SB-GA8-2014-115

Service Bulletin

Installation of fire-resistant washer and inspection of engine isolator mount orientation

All GA8-TC 320 aircraft up to and including serial no. GA8-TC 320-14-205

Figure 1: Mount Installation

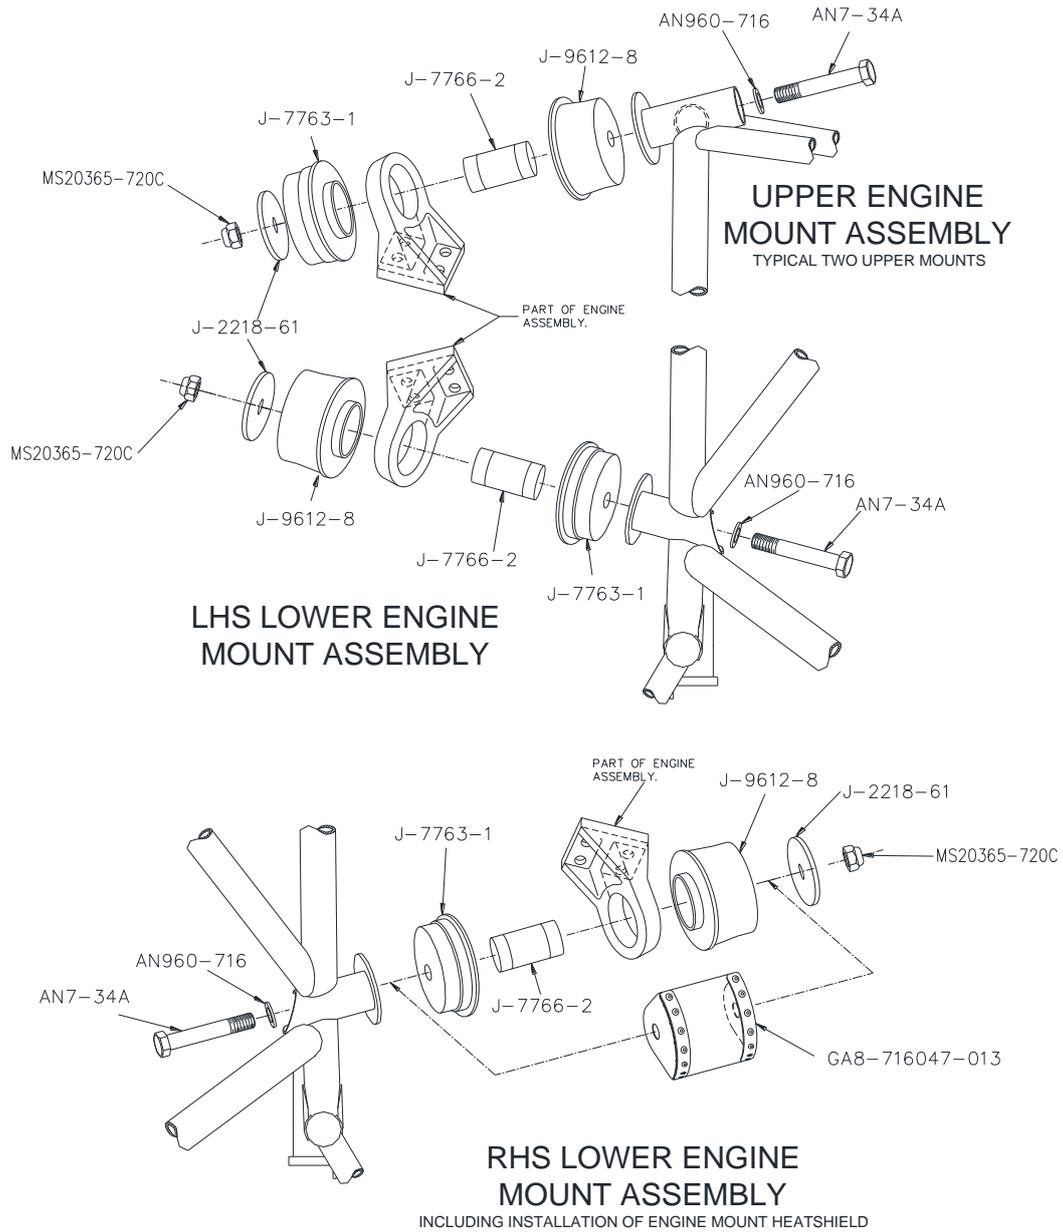
A recent review of the engine mount installation on the Turbo Charged GA8 Airvan has prompted the release of this Service Bulletin. Model GA8-TC 320 aircraft require the installation of a steel washer at each of the engine isolator mount locations to address a potential risk of reduced engine retention capability in the event of a fire. The potential loss of engine retention capability would only occur in the event of extreme temperatures sufficient to result in the loss of the strength of the aluminium in the sandwich mounts.

1. Remove the engine cowls in accordance with the applicable Service Manual.
2. Verify that the installation of the engine isolator mounts includes a steel washer J-2218-61 (shown in Figure 2 below). Proceed to step 3 if the washers have not been installed, otherwise skip to step 10.

3. Relieve the weight of the engine from the isolator mounts using an appropriate hoist.
4. Check the orientation of the engine isolator mounts to verify that the mounts have been installed in accordance with Figure 1. Specifically mount part no. J-7763-1 must be positioned on the compression side of the engine lug. For upper mounts this would be on the forward side and for the lower mounts this would be on the aft side of the engine lug. The part number of the mounts can be found moulded into the elastomer on the periphery of the mount. A depiction of the mounts is shown in Figure 2. If any of the isolator mounts are not installed in accordance with Figure 1, proceed to step 5, otherwise skip to step 8

6. Re-install the isolators such that they are oriented in accordance with Figure 1.
7. Inspect the cowls for evidence of damage caused by excessive drooping of the engine. If damage is found, contact GippsAero for further assistance.
8. Regardless of mount serviceability, a J-2218-61 steel washer is to be installed on the forward side of each of the four engine isolator mount locations. The AN7-33A bolt is to be replaced with an AN7-34A bolt, verify correct length upon installation. Depending on bolt grip length the existing AN960-716 washer maybe retained or discarded. Ensure that engine mount retention bolts are torqued to 450-500 in-lb per Chapter 20-10-00 of the Service Manual.

Figure 3: Middle Aft Baffle Cover Plate

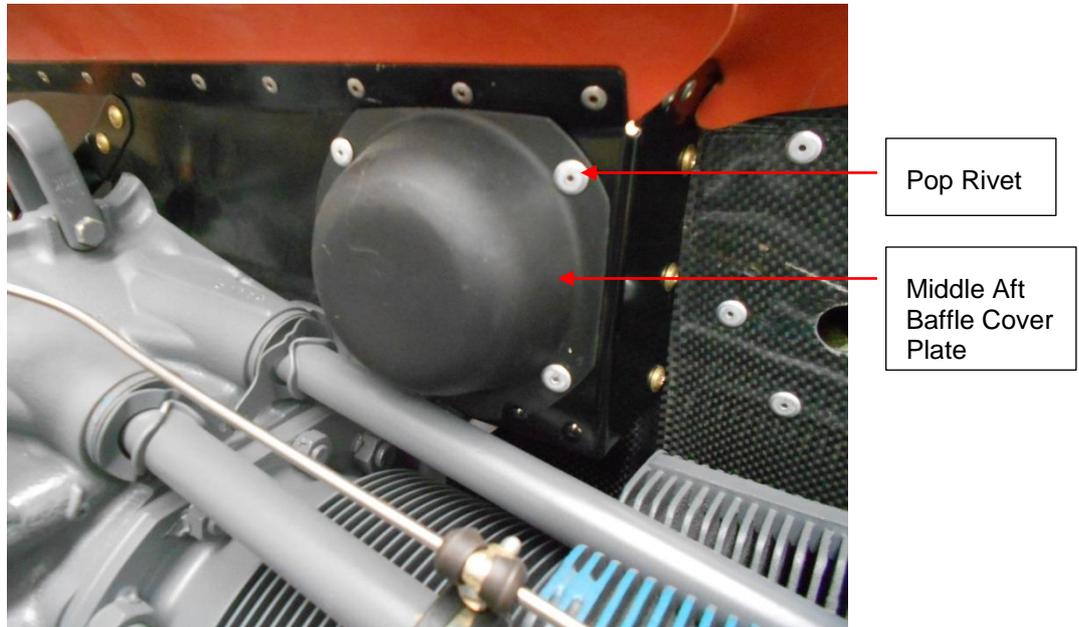
If required, carefully drill out the 8 pop rivets holding the two middle aft baffle cover plates to gain access to the top engine mount locations (Figure 3) ensuring all swarf is cleared off the work area. When gaining access to the lower engine mount locations ensure that surrounding installations including hoses and electrical cables are not damaged.

9. If removed, re-install the two middle aft baffle cover plates using 8 TLPD 48LF pop rivets.
10. Re-install the engine cowls and proceed to the documentation section of this Service Bulletin.
